Millennium Bulk Terminals- Longview Comment

Millennium Bulk Terminals (MBT) is a current operator, seeking to increase their business by exporting 44 million metric tons of coal per year to Asian countries with relaxed coal fuel regulations out of a port on Washington state's Columbia River Basin. This comment reviews the Millennium Bulk Terminal Environmental Impact Statement (EIS) and details the following faults or omissions that will be addressed in turn: 1. The proposed scope of the facility does not effectively cover impact area of the coal transported to the facility. 2. Even though the footprint of the facility was approved as the scope of the facility, under NEPA's Cumulative Impact environmental policy, the railways to the source must be included because they include a known significant impact. 3. Coal dust hazards and surfactant composition and environmental impacts are in need of review. Both materials have differing hazards omitted from the MBT EIS, and need to be included to sufficiently cover the impacts of the facility. 4. The building of the terminal should be in line with current US policy to limit fossil fuels and shift to renewable or clean energy sources, by b

Figure 1. BNSF and UP Railways used for the Millennium Bulk Terminal project.

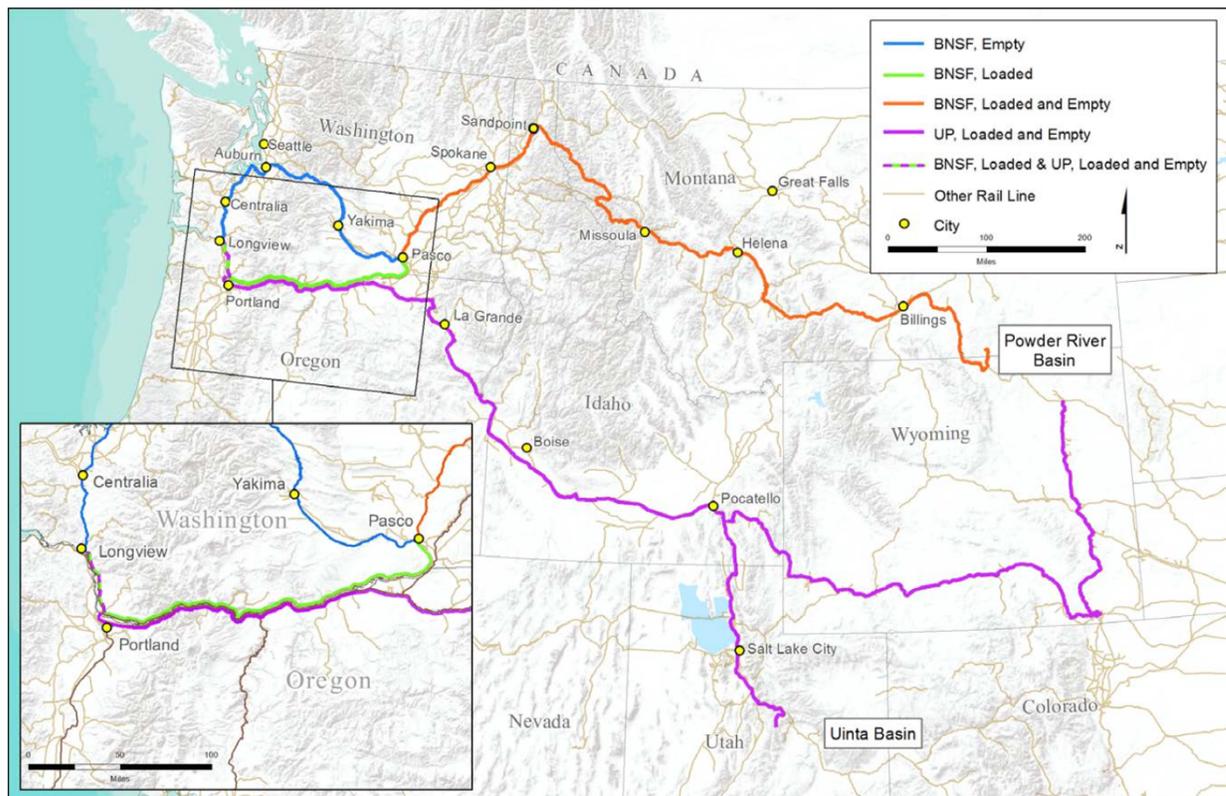
non-toxic dust materials as is the case with coal dust.^{3,4} Coal dust toxicity results from not just the physical blocking caused by particulates caught inside and trapped in the lungs forever, but also from the reactions of the components with normal bio-reactions and processes.^{2,3} In-depth studies showed coal dusts increased the up-regulation of important leukocyte recruiting factors including those which induce inflammation (LTB4), regulate cell activity and are characteristic of cancer (PDGF), brain inflammation (MCP-1), and immune responses (TNF-alpha) which are characteristic of Alzheimer's disease, cancer, inflammatory bowel disease, among others.² Coal dust attacks reactive oxygen species and related antioxidant protection mechanisms along with cytokines, growth factors, and related proteins.² All of these diseases would be expected to increase around the area of the coal transport, given in Figure 1.

For the purposes of Millennium Bulk Terminal's EIS report, measurements along the rail should be taken to ensure that no one is within the problem zone of the the physical complications of coal dust. In the case of the animals inhaling the coal dust, including those endangered species, fencing or other limiting barriers must be considered to keep them from the area of the coal. Although not discussed here, but some of the 200,000-1.3 million tons of coal lost in the transport will inevitably end up in water sources along the railway and be carried further than the toxic dust discharges from the cars themselves. More research is suggested for the implications of coal dust in the water supply in a supplemental EIS.
